N4903A-01A-S

S E R V I C E N O T E

N4903A, High-Performance Serial BERT

POSSIBLE FIRE HAZARD

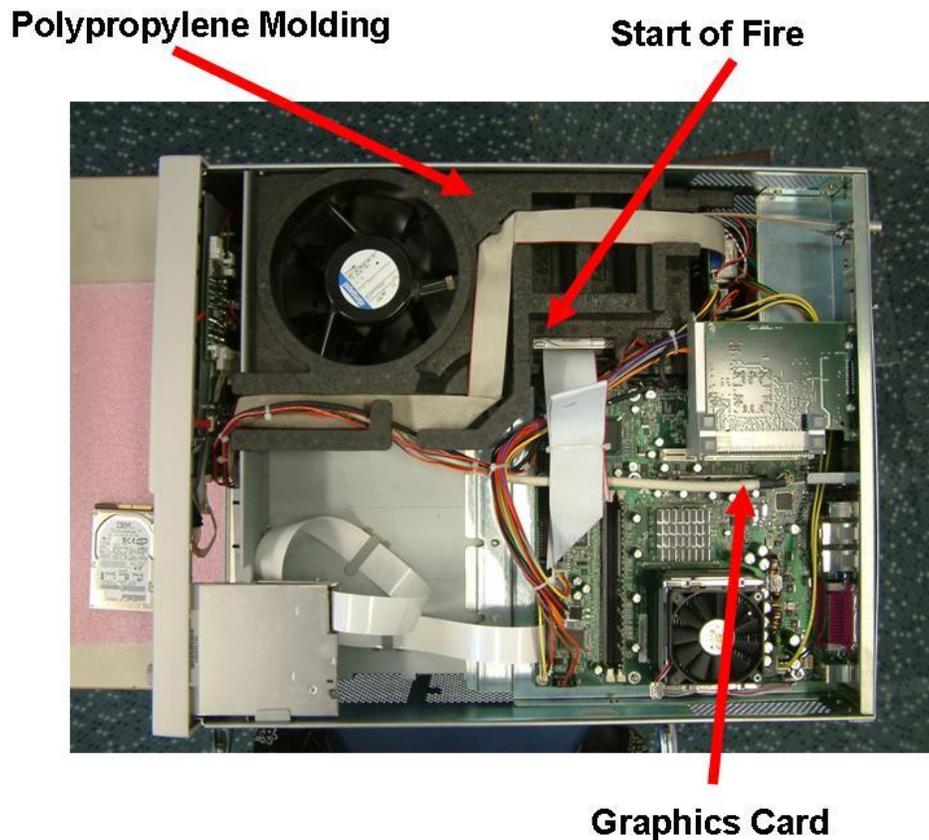
A surface-mount ceramic capacitor suffered physical stress during the manufacturing process, leading the capacitor to crack. During operation this crack placed stress on the internal structure of the capacitor, and caused the plates to short together. (The plates are separated by very little space, made up of very thin insulators.) This caused the capacitor to have very low residual impedance, resulting in a very high current conducted through the capacitor and the 12V path on the motherboard for some period of time. The low impedance didn't lead to a current high enough for blowing the fuse. Therefore the higher current was available long enough to create a very high temperature ($T > 300^{\circ}\text{C}$) The high temperature ignited the polyurethane molding used to conduct the airflow for cooling through the instrument.

The following photo illustrates the layout of the instrument. It shows the polypropylene molding, the graphics card and the starting point of the fire.

The countermeasure for this issue is to exchange the graphics cards. The new graphics cards are produced with an improved manufacturing process eliminating the risk of micro cracks. They either have an additional fusing to protect the 12V path or they have eliminated the 12V path altogether. The graphics card can be exchanged by Agilent authorized personnel only.

Motherboard still considered being good – no exchange required:

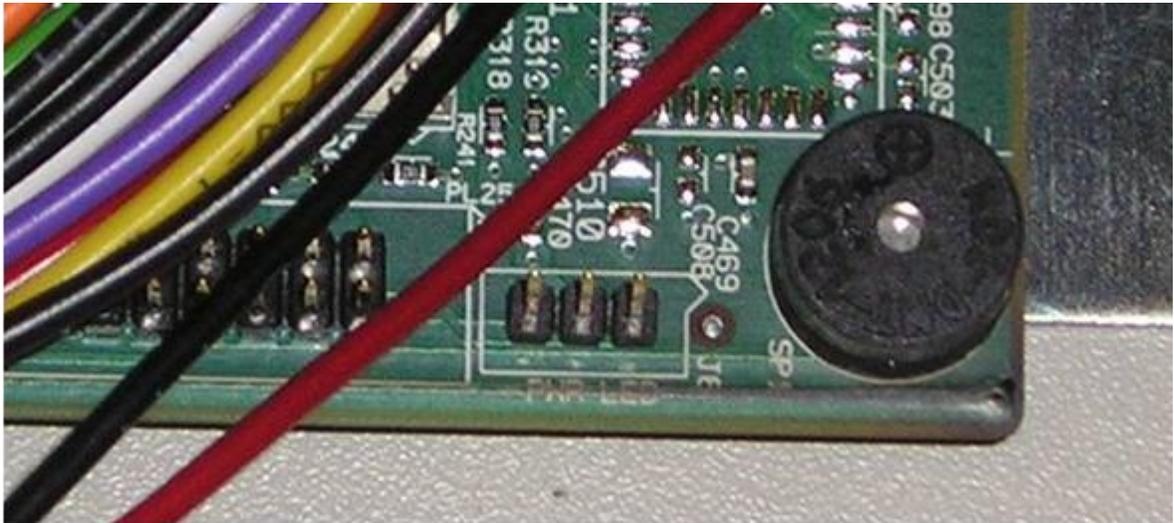
There might be discoloring on the PC motherboard in the shown corner (brown color). This can be ignored. The function or the quality of the motherboard is not affected by this.

Motherboard considered being bad – please exchange:

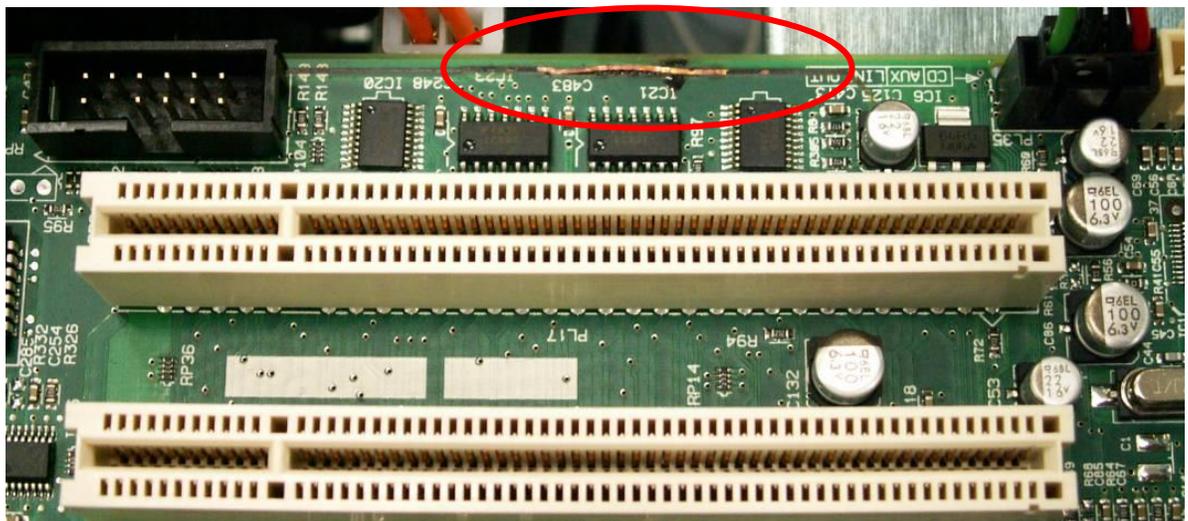
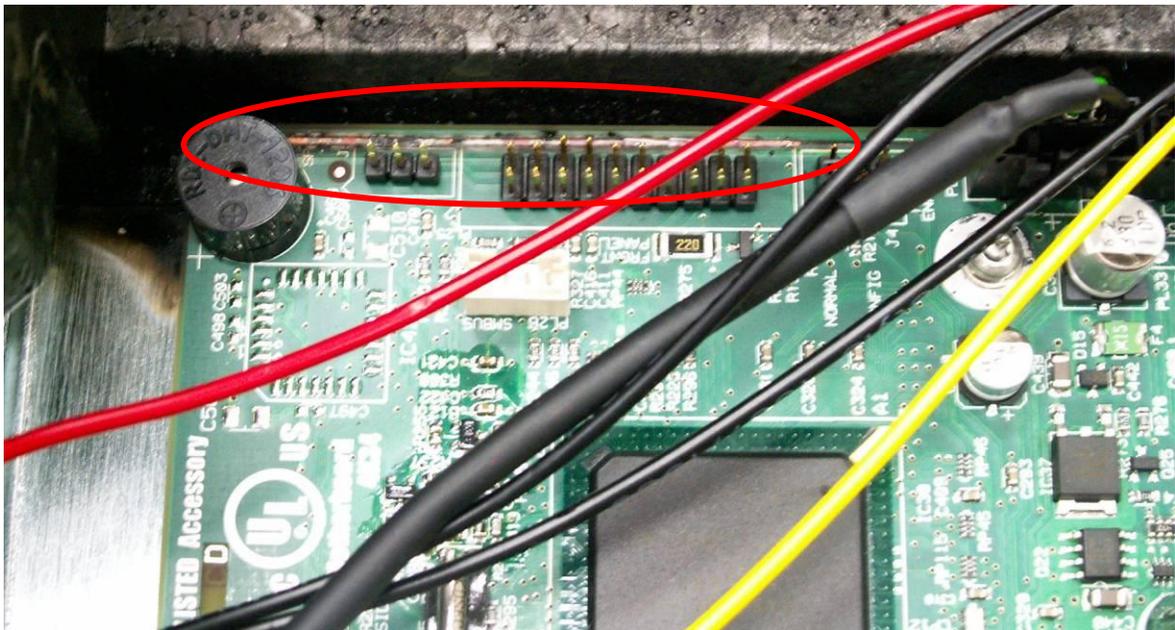
In very exceptional cases if you see traces of smoke or fire, the motherboard needs to be exchanged. In these cases typically the integrated display of the instrument would not work anymore. The exchange of the motherboards can only be done in the Service Center - onsite repair is not possible.

The following discoloring is intentional – no exchange required:

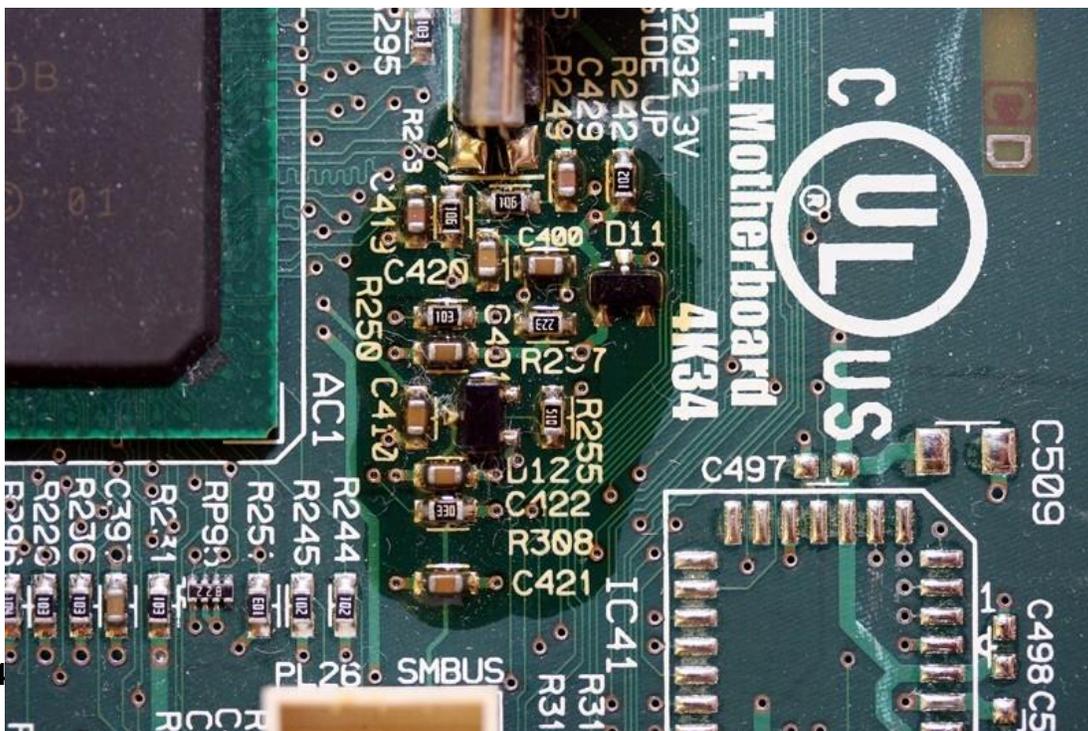
This effect is caused by an intentional sealing of a high impedance area to avoid issues in environments with a high degree of humidity. No exchange of the motherboard is required here.

- Sample #1 (Revision NM2501):

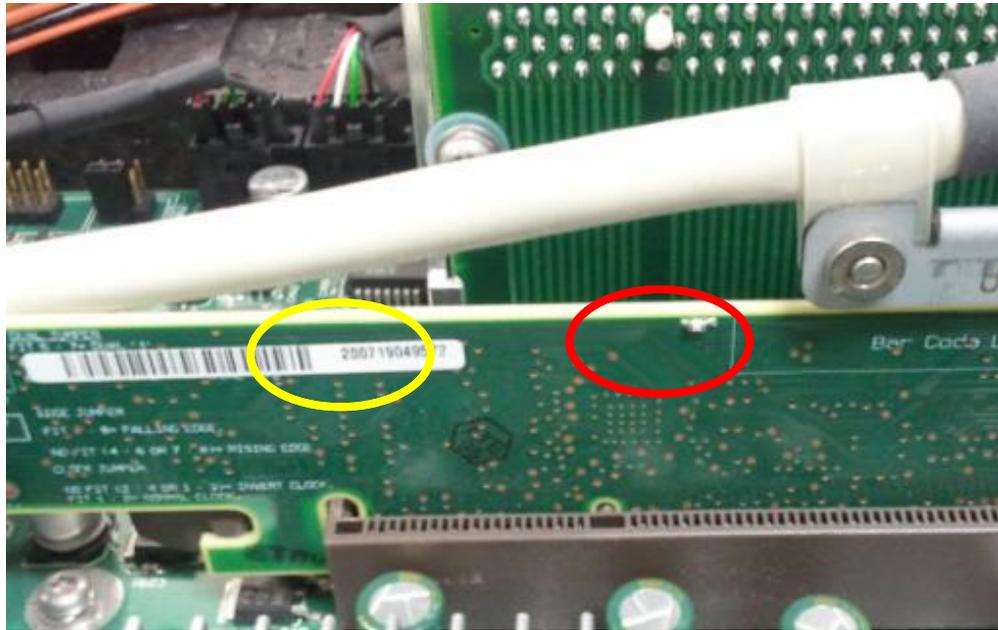
The board has a fuse on top (red circle) and a serial number (yellow circle) starting with 200... In the case above it is 200719049572)

- Sample #2 (Revision NM2502):

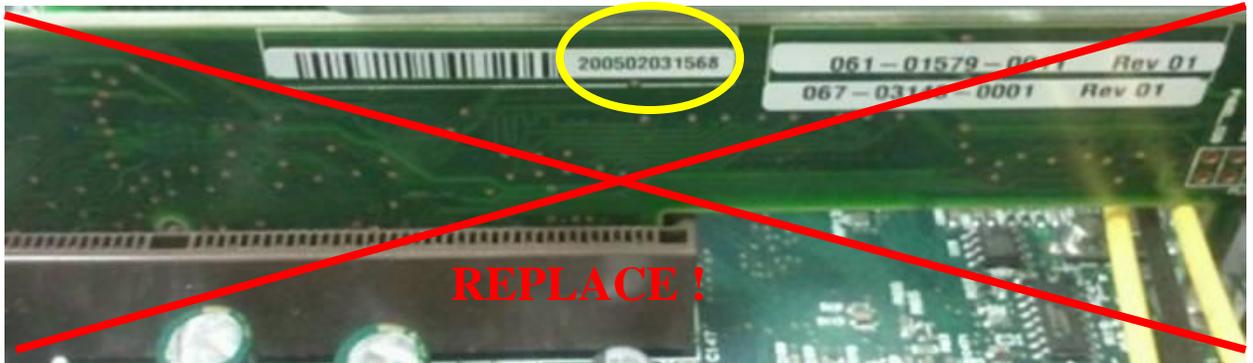
The board has a serial number (yellow circle) **NOT** starting with 200... In the case above it is: 501022501024.

shows a serial number starting with 200... AND no fuse is visible

it is potentially **hazardous** and the **unit must be set out of operation** until the graphic board is replaced (part number: N4901-66577 or N4901-69577). The graphic board can be exchanged without impacting the instrument's performance.
